**T****Service Bulletin  
Index****TWO STROKE**

Subject: T500 TRANSMISSION REPAIR

Bulletin No: T-1  
Date: May 1, 1975

T500 Transmission Repair

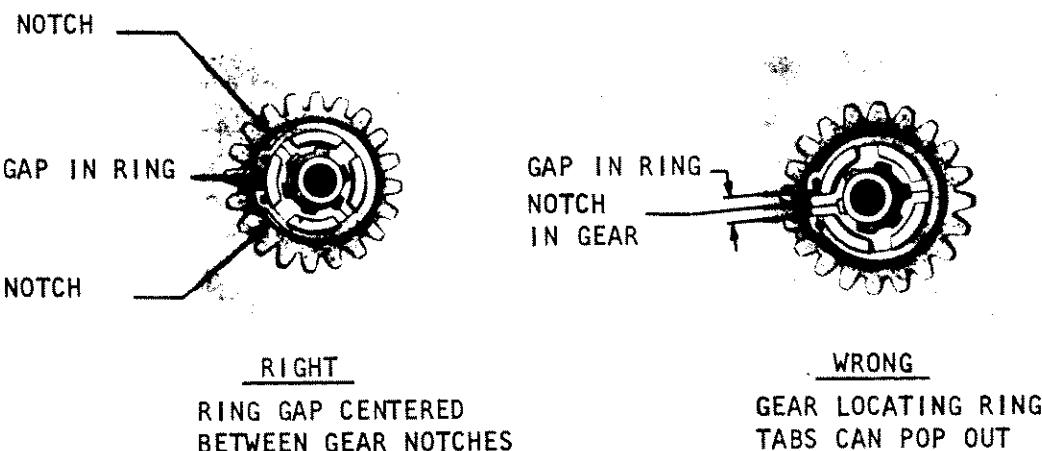
A. Do not interchange low gear slider wheel with 3rd gear slider wheel. If the transmission is assembled this way, the bike will jump out of first gear under any load. The difference between the two wheels is shown below:

B. Do not switch the small needle bearing bushings on the ends of the transmission shafts. One is marked with a "D", this should be installed on the driveshaft (shaft with sprocket). The height of the two bushing pins in the case should not be more than 1.5mm (.060"). File off any excess height.

Subject: T250, T305, T350 DRIVE SHAFT/TOP GEAR

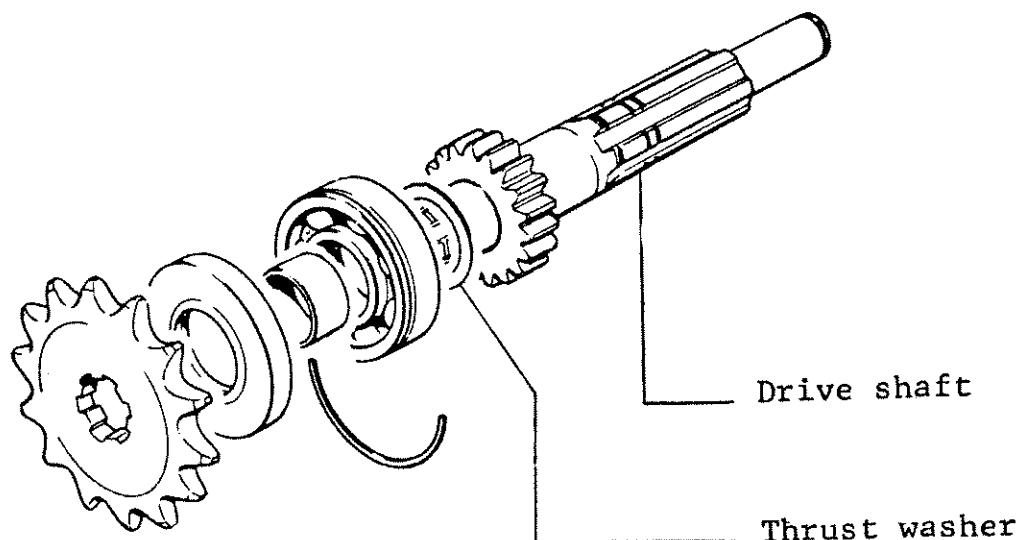
Top gear, driven, on the subject models has been increased in thickness and strength.

When using the new style driveshaft #24131-18002 with old style crankcases, the thrust washer #08211-22341 must be eliminated.

In the event that new cases are fitted and the old driveshaft re-used, washer #08211-22341 must be retained.

Subject: T500 INCREASED TRANSMISSION OIL CAPACITY

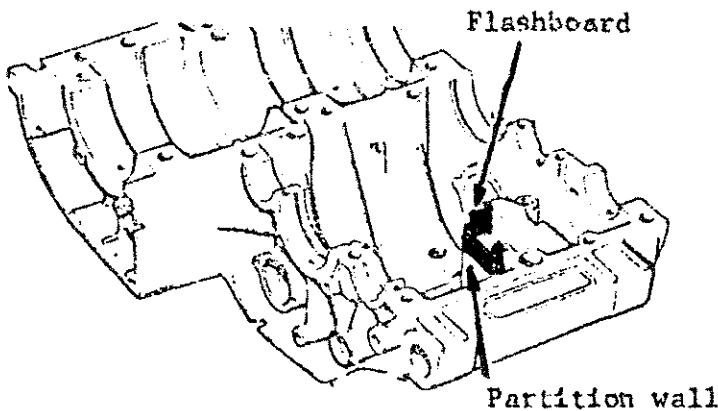
To effectively increase the durability of the T500 4th and 5th gears, the transmission oil capacity has been increased from 1200cc to 1400cc. The increased oil capacity has been applied to the T500 since the beginning of the 1974 "L" model production.

A rubber flashback applied to the primary oil transfer chamber in the lower crankcase half is used to accommodate the increased oil capacity. The flashback keeps the additional oil from entering the primary case, and therefore protects the clutch from excessive drag.

The flashback in position is illustrated below.

Service AMRSubject: T500 SWING ARM PIVOT SHAFT

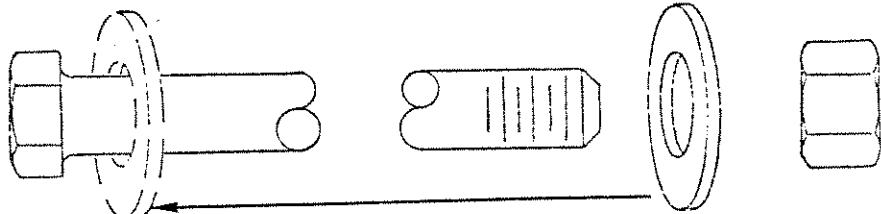
The shoulder radius of the T500 swing arm pivot shaft has been increased from 0.5mm to 1.0mm.

To accept the new type pivot shaft, the frame boss chamfer has also been increased 0.5mm.

**NOTE:** Should it be necessary to install a new type pivot shaft through an old type frame boss, simply move the washer from the nut side to the head side of the swing arm pivot shaft. The washer will conform to the shoulder radius of the pivot shaft.

Bottom View of  
Lower Crankcase Half

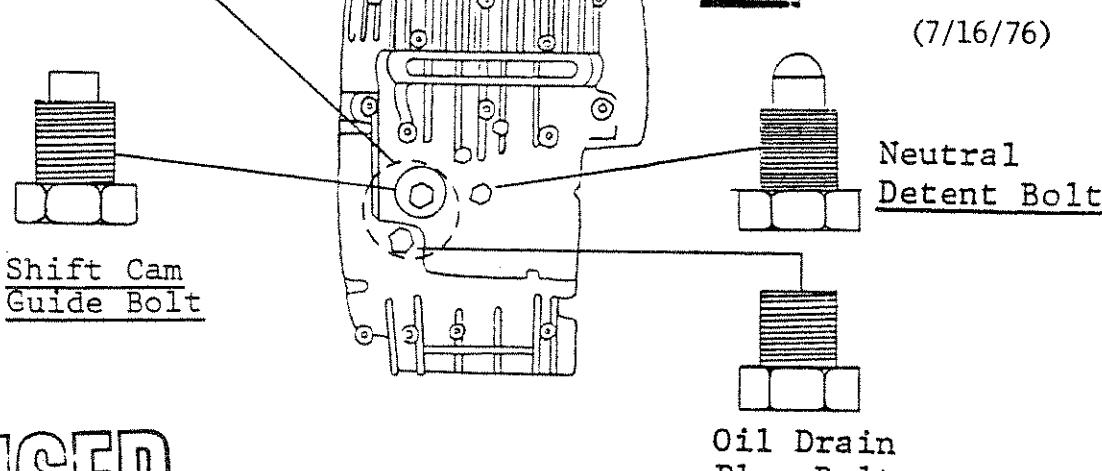
We have received occasional reports of T500 transmission failure immediately after an engine or transmission overhaul. Upon disassembling and inspecting the transmission, two situations have been found. The first reason a transmission would fail was that an oil drain plug bolt from another model Suzuki (Example TS185/250) had been interchanged with the shift cam guide bolt during the overhaul. The second reason for the transmission failure was due to a magnetic oil drain plug that had been substituted instead of the shift cam guide bolt.

In both situations the bolt did not extend into the locating groove of the shift cam drum far enough to restrict the shift drum from sliding from side to side in the crankcases. When this happens the shifting forks slide with the shift cam, allowing two sets of gears to become engaged at the time. This results in severe damage to the gears, and requires their replacement.

Note: Remove both  
bolts to drain  
transmission  
oil.

Therefore, whenever a T500 is overhauled, or the transmission oil changed by your service department, the final inspection after reassembly should be the proper placement of the shift cam guide bolt.
